PCN-20230705 TE0703-06 to TE0703-07 Hardware Revision Change

Company	Trenz Electronic GmbH
PCN Number	PCN-20230705
Title	TE0703-06 to TE0703-07 Hardware Revision Change
Subject	Hardware Revision Change
Issue Date	2023-10-13

Affected Product	Replacement
TE0703-06	TE0703-07

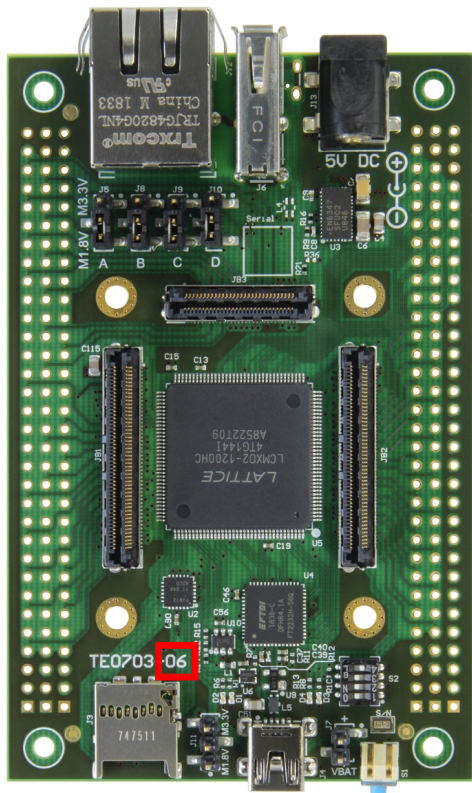
The revision number is shown on the top side of the PCB. Revision number position changes between REV06 and REV07 on top side of the PCB.
